# Coniston Generating Station Life Extension Project

**Supplementary Report (Final)**

July 2024

Figure 2-1 Revised 2024 Project

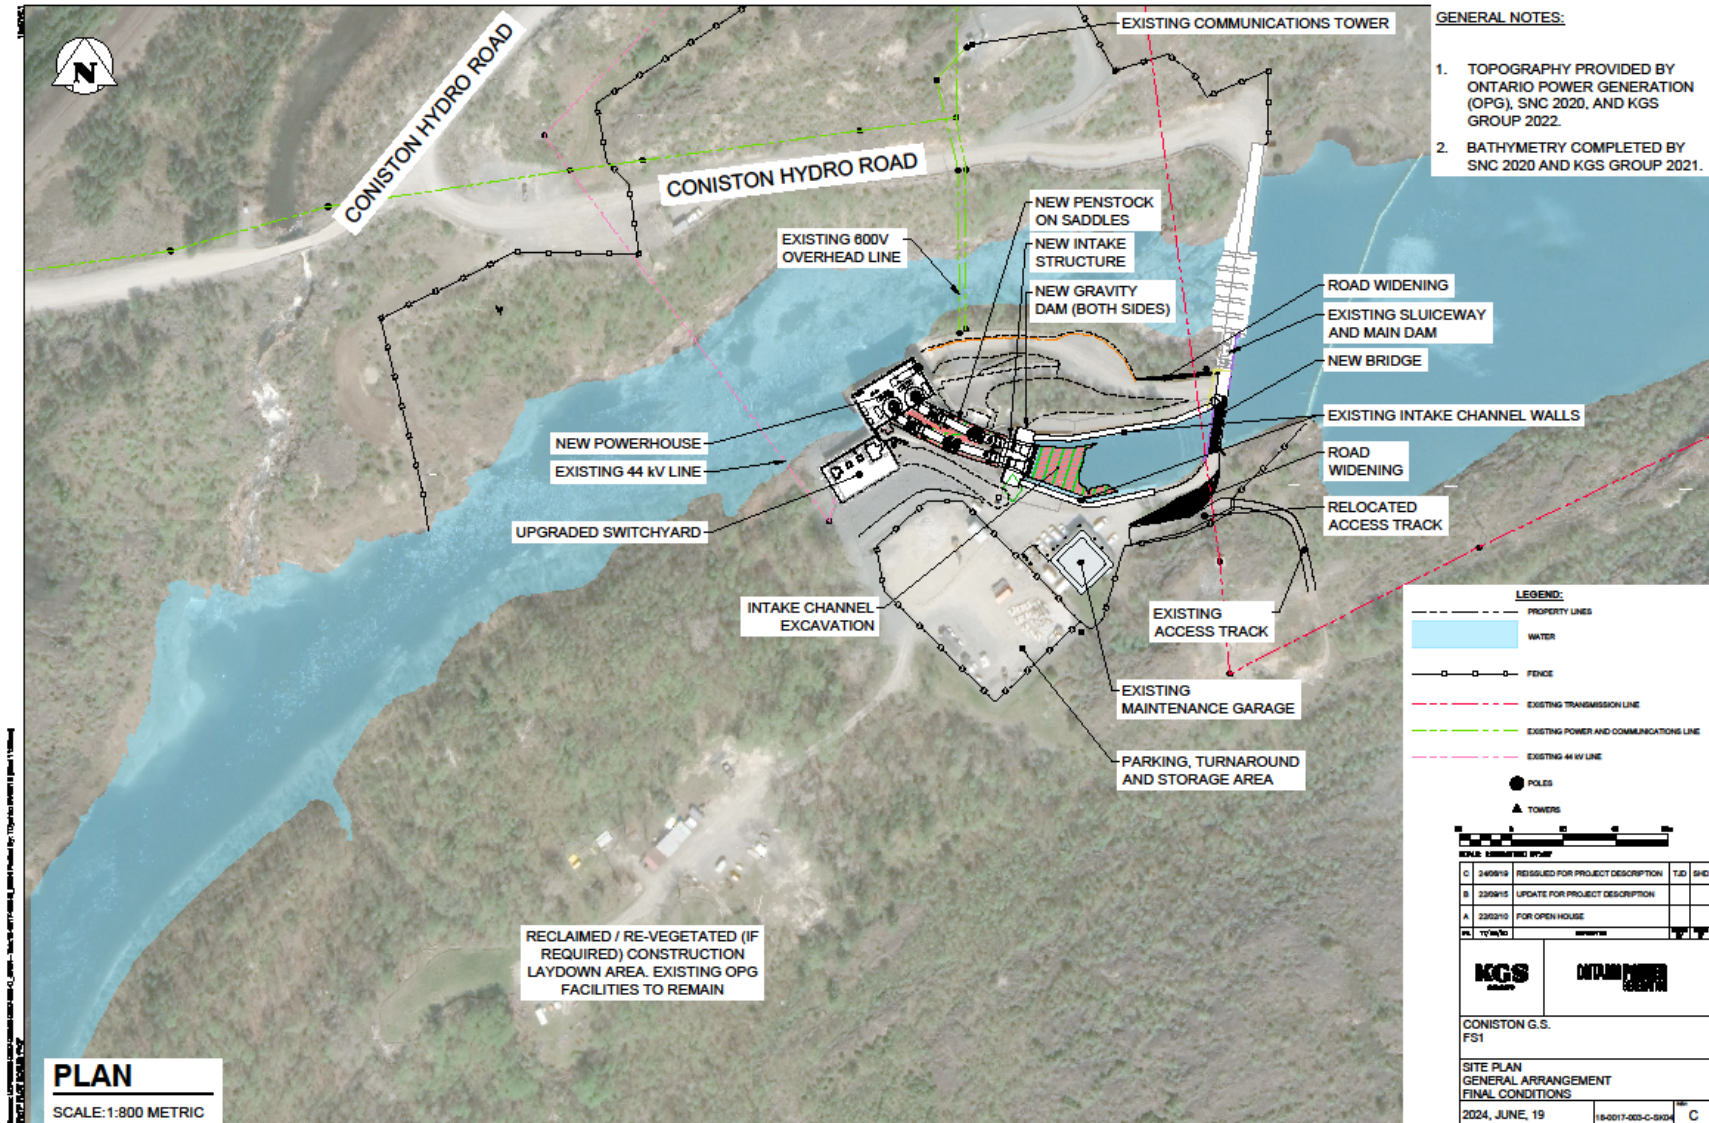
- The proposed powerhouse will now be situated on the footprint of the existing powerhouse and utilizes portions of its existing substructure. The concept proposed in the 2023 Project (as presented in the Class EA ER and Figure 2-2 below) showed a new powerhouse location upstream of the current one.
- Replacement of the proposed SAXO or Kaplan Turbines with a new DIVE Turbine option.
- Eliminating the intake velocity work and major civil canal changes (reduced canal excavation, maintain existing canal walls, reduced site grading).
- Moving the upstream cofferdam to within the intake canal, thereby reducing the area of, and within, the upstream cofferdam.
- Eliminating or reducing the area and duration of the downstream cofferdam.
- The Bridge Replacement will maintain the existing abutment locations and centre pier. The work may be done in advance of the majority of the work.

The 2024 Revised Project is shown below in Figure 2-1.

Figure 2-4 2024 Project General Arrangement Construction Stage

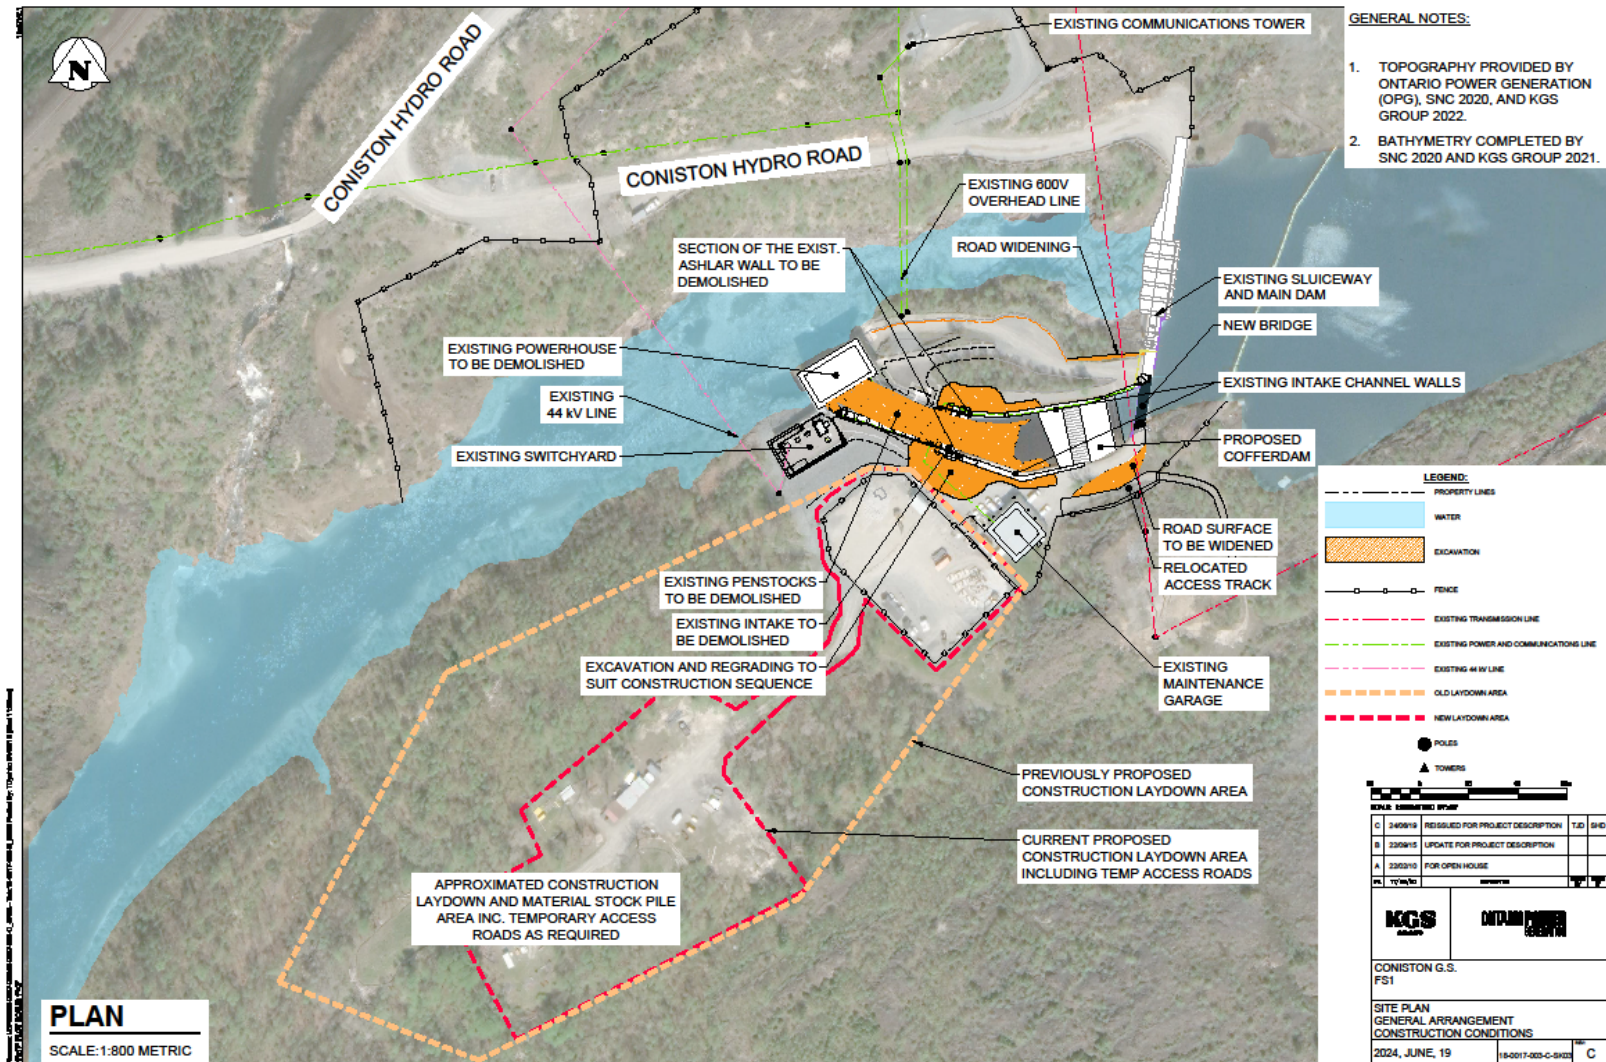
The temporary construction stage laydown and materials stockpile area is also reduced in size (see Figure 2-2).

Figure 2-4 below shows the Revised 2024 Project for the construction stage.
